**Addendum No. 3
January 24, 2024**

Project: **Lennox High School Addition**
Lennox, South Dakota
Architecture Incorporated Project No.: 2982

1) SHEET 9.11 – SITE PLAN – ELECTRICAL

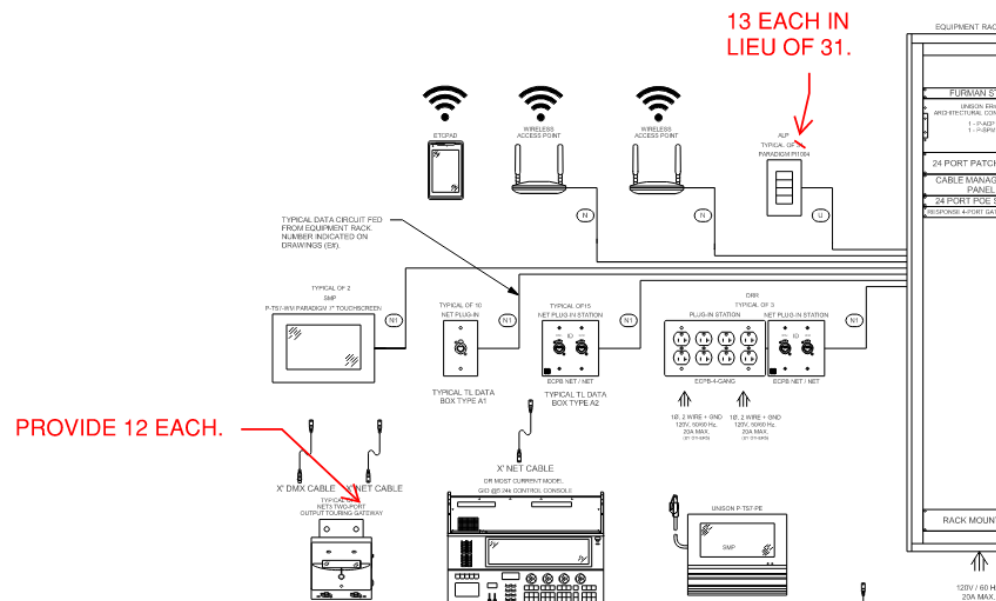
-
- APPROXIMATE TENNIS COURT UNIT SUBSTATION AND LOAD CENTER LOCATION, VERIFY EXACT LOCATION WITH CIVIL ENGINEER.**
- 7" CONCRETE PAVEMENT**
8" AGGREGATE BASE COURSE
- 8" SCARIFY & RECOMPACT SUBGRADE**
- PROVIDE WP DUPLEX RECEPTACLE WITH IN-USE COVER, MOUNT ON FENCE POST AT APPROXIMATELY 46" AFG. CONNECT TO A 20A/1P GFI CIRCUIT BREAKER IN LOAD CENTER.**
- 21' (TYP.)**
COURTS 1 & 2
12'
18'
21' (TYP.)
COURTS 3 & 4
COURTS 5 & 6
FUTURE COURTS
- ADD ALTERNATE NO. 2 = COURTS 1 THRU 4**
ADD ALTERNATE NO. 3 = COURTS 1 THRU 6

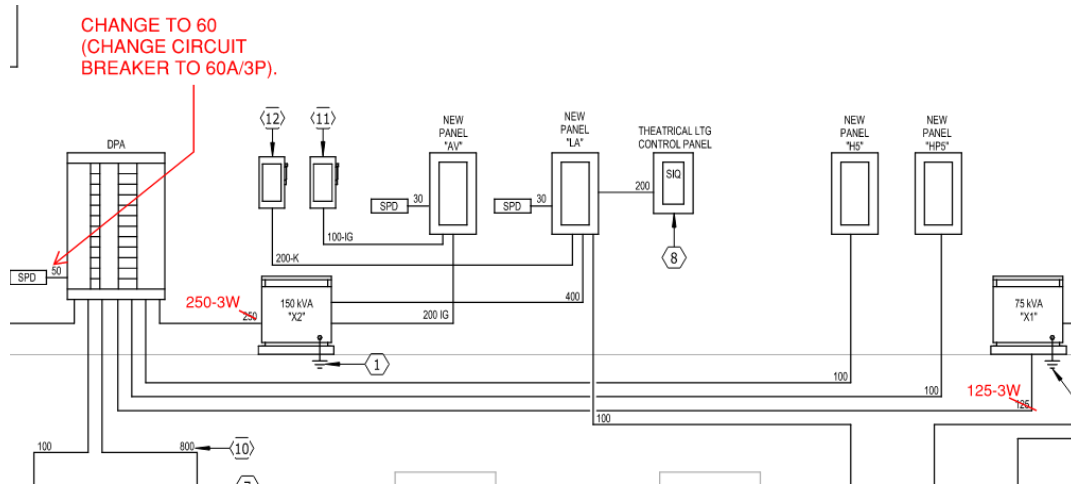
a) Reference the snip below for revisions to the theatrical lighting power & control riser diagram.

TENNIS COURT POWER RISER DIAGRAM
NO SCALE
PART OF ALT #2 & #3

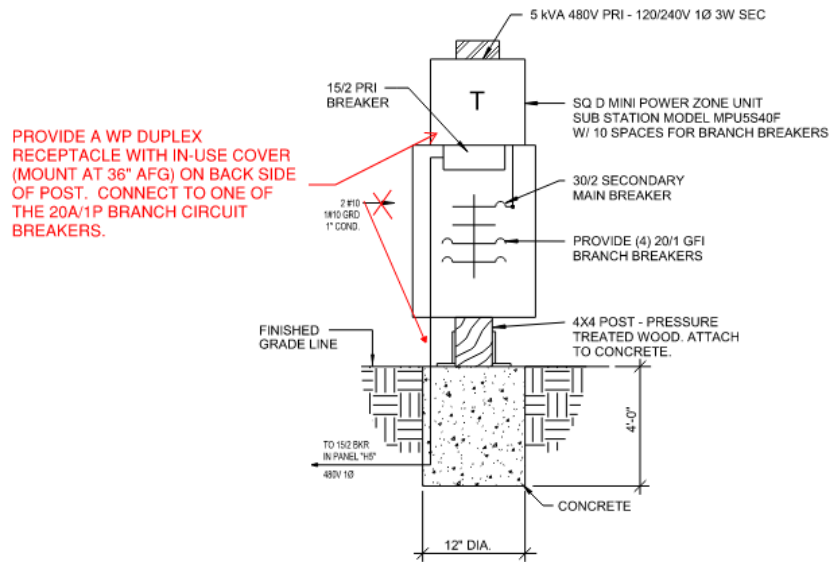
- a) Reference the snip below for revisions to the tennis court unit substation and load center detail.
